V1 - CD 22-05

THE POINT - PHASES 11-13

CONSTRUCTION DRAWINGS

PROJECT NUMBER: AWH-20000
DATE: OCTOBER 27, 2022

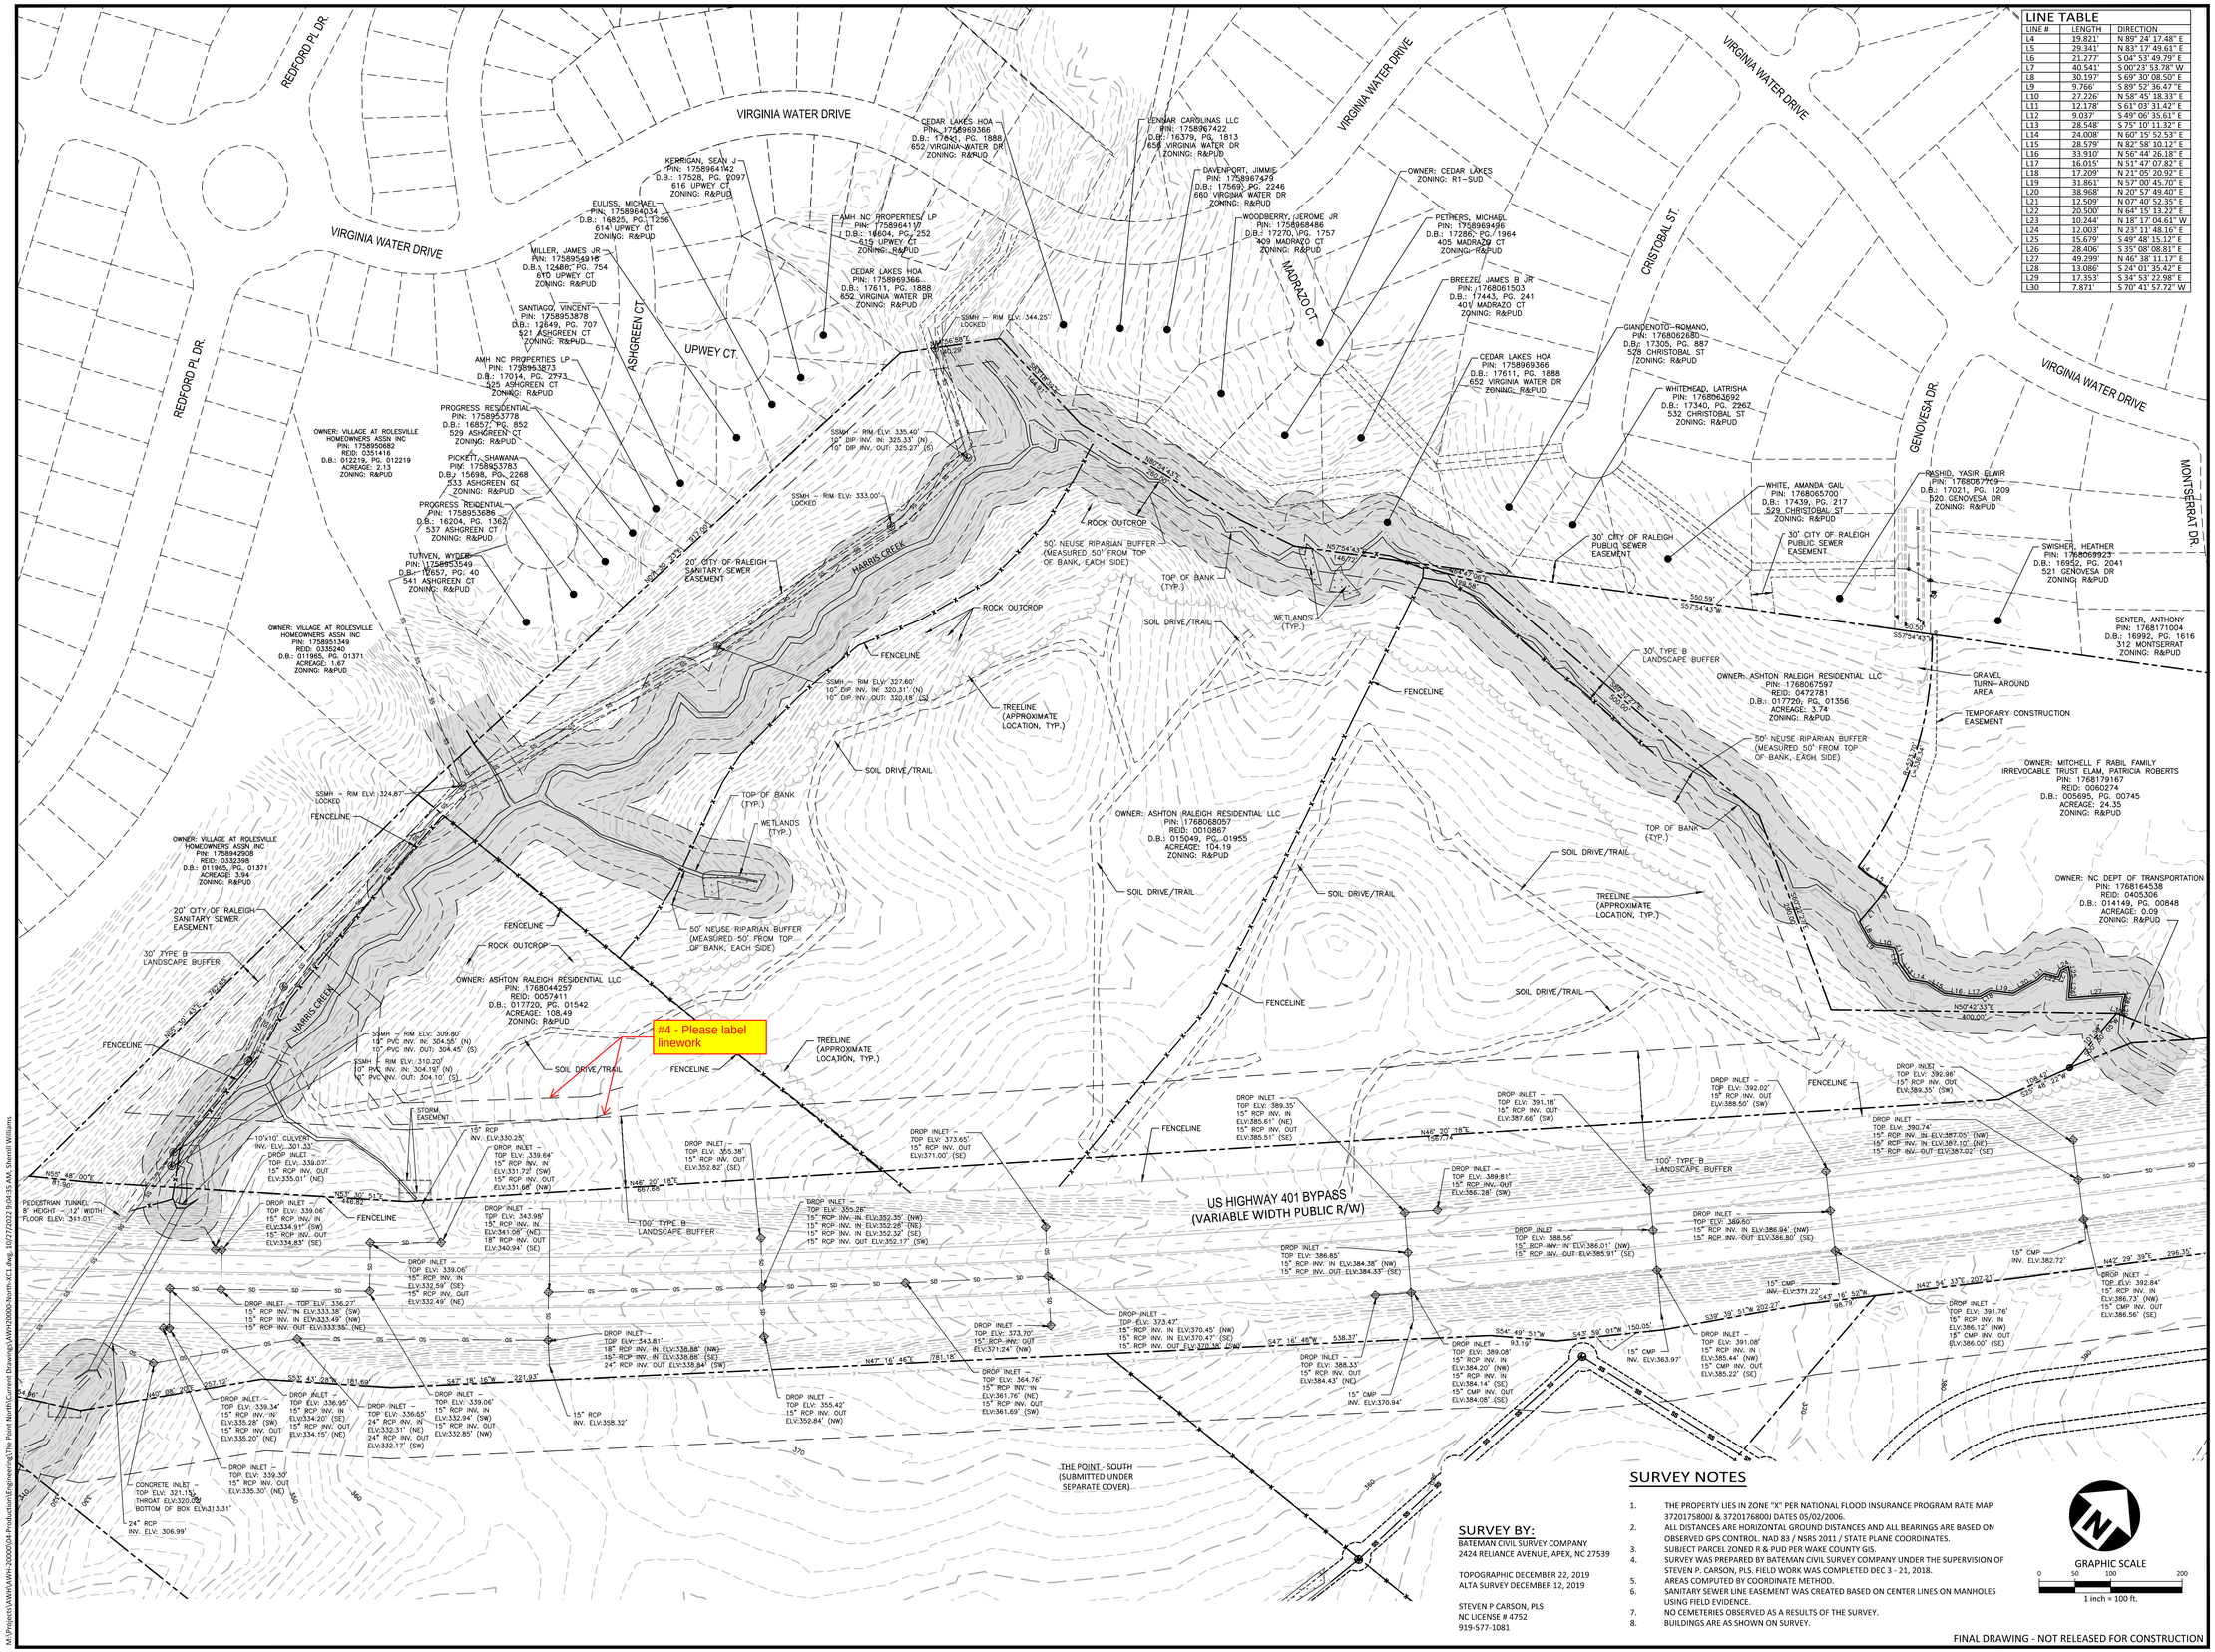
#2 - While we recognize the PR was approved with this typical section, to comply with changing Town preferences, is it possible to place the sidewalk 1' off the right-of-way? This would also provide a wider boulevard for plantings and street trees if being provided.

#3 - Per the Rolesville greenway plan, the goal is that greenways should still be accessible; a max cross slope grade of 2% is required

If there is a reason this greenway does not intend to be accessible, please provide clarification.

RADIANT WAY

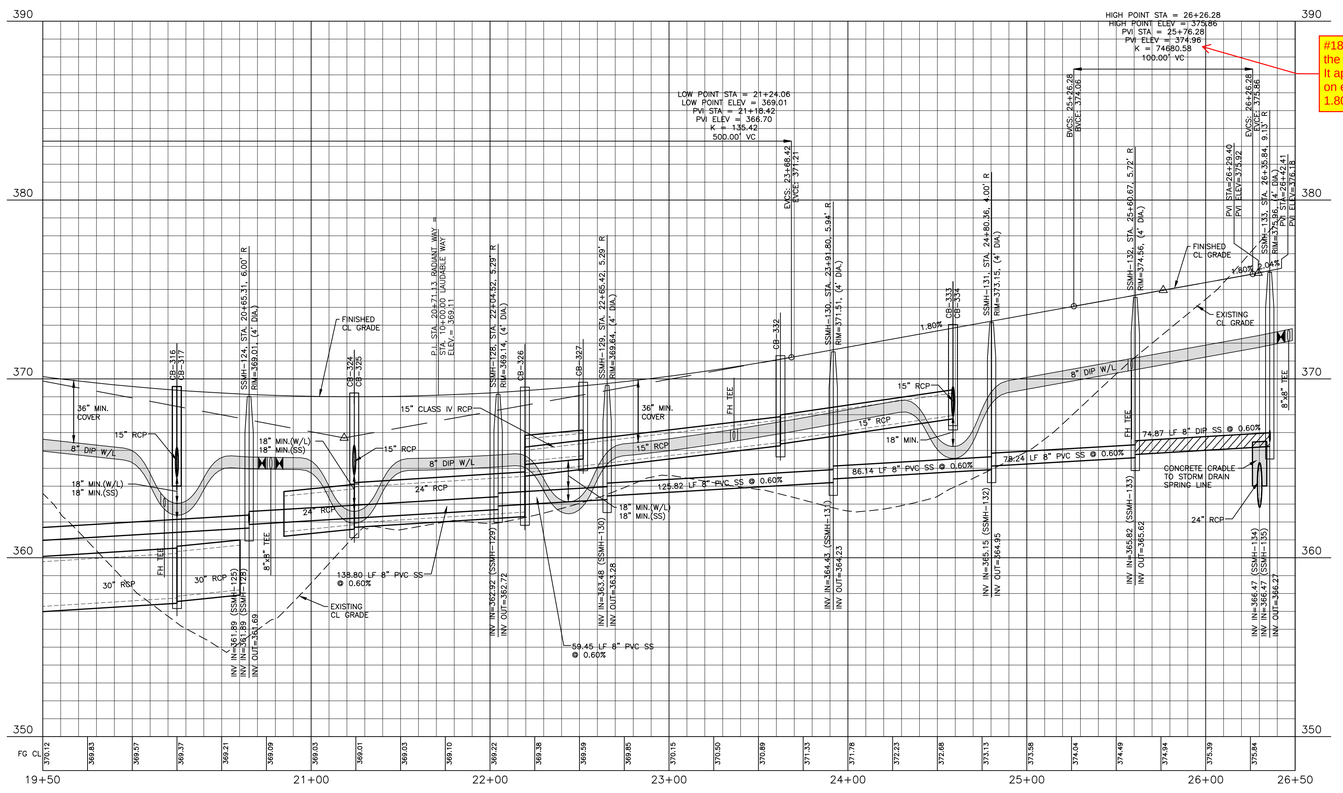
#18 - Please confirm the need for a curve. It appears the grades on each side are both 1.80%
